JUKSKEI VIEW EXT 128 – BULK SERVICES AVAILABLILITY

APPENDIX F3: LETTER FROM GDRT – COMMENTS ON ACCESS ROAD

PROPOSED TOWNSHIP: JUKSKEI VIEW EXTENSION 128

TOEPASSING VAN VERSKILLENDE GEVALLE / APPLICATION OF DIFFERENT CASES

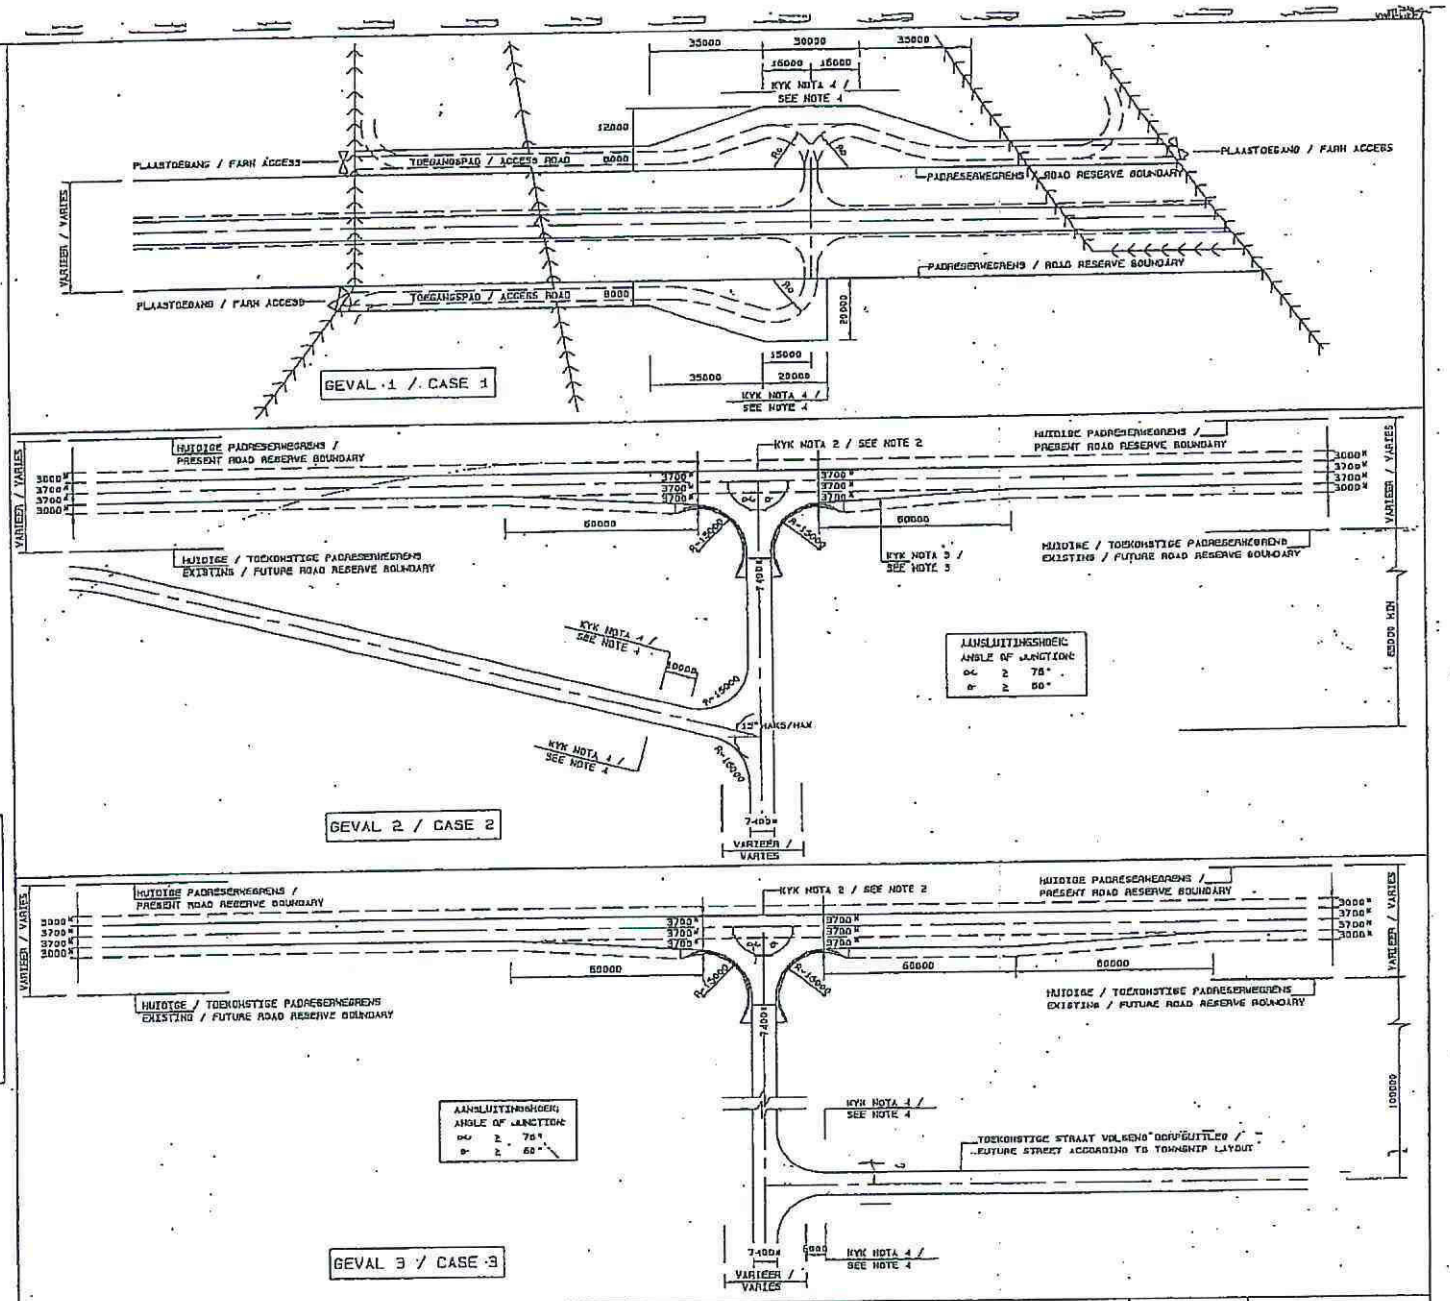
Provision must be made for the road reserve splays at the access point to road **P1-2(K101)**, at **ROAD ACCESS "A"**as indicated on
Plan No: **22458/1** annexed hereto. (Refer to typical plan GRP 5/1, for splay measurements).

Provision must be made for the road reserve splays at the access point to road **P1-2(K101)**, at **ROAD ACCESS "A"**as indicated on
Plan No: **22458/1** annexed hereto. (Refer to typical plan GRP 5/1, for splay measurements).

APPLICATIONS:

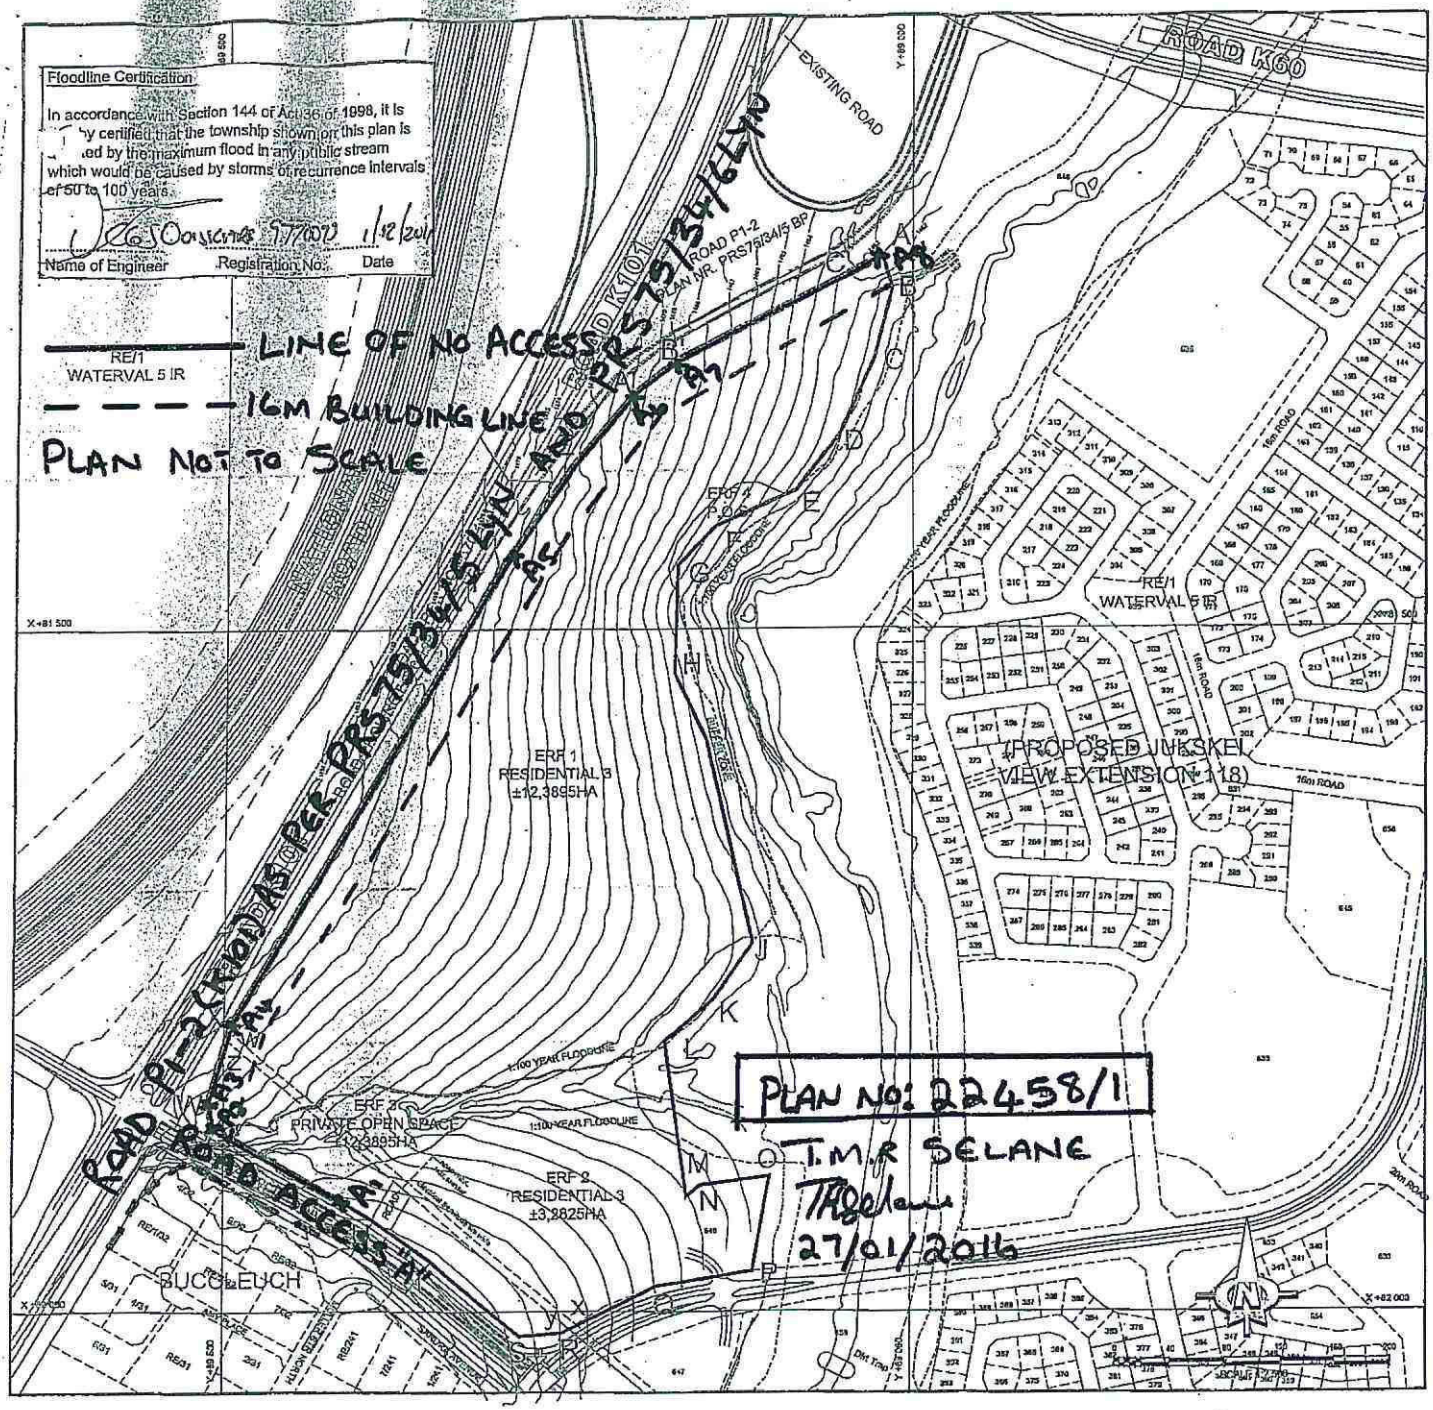
2.6.1 Service roads shall be remote and separated from the road by means of at least one row of erven. (Refer to Typical plan GTP 3/2-case 3).

2.6.1 Service roads shall be remote and separated from the road by means of at least one row of erven. (Refer to Typical plan GTP 3/2-case 3).

JUKSKEIVIEW EXTENSION 128

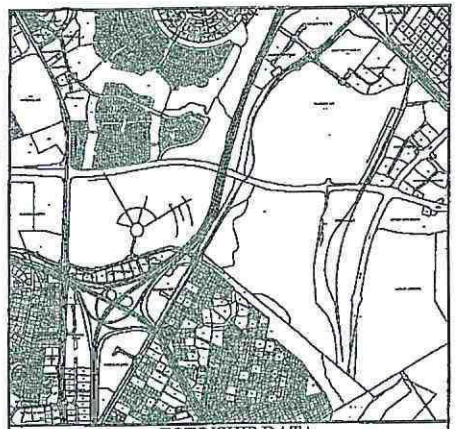
Ingress to and egress from the road **P1-2(K101)** will be **provisionally** allowed at **ROAD ACCESS "A"** and shall also comply with the requirements of paragraphs 2.3.1 to 2.3.5.

ROAD ACCESS "A" must be at least **25m** wide and must be determined in conjunction with the Local authority. **This width is the minimum street width required. However, a wider street reserve might be required, depending on site-specific characteristics. To ascertain the required street reserve width, a detailed investigation must be undertaken at the access point taking the existing and future design of the provincial road into account.**

No ingress to or egress from the above road will be allowed along the lines lettered A_1-A_2-A_3-A_4-A_5-A_6-A_7-A_8 as shown on the plan mentioned in paragraph 6.1 in red (solid).

Building restriction areas, which are in compliance with the requirements of EXECUTIVE COMMITTEE RESOLUTION 1112 of 26 June 1978 shall be provided. The building restriction lines are shown in green (dotted) on the plan mentioned in paragraph 4.1.

No buildings or structures may be erected within the building restriction of 16 metres from the reserve boundary of road **P1-2(K101)**.
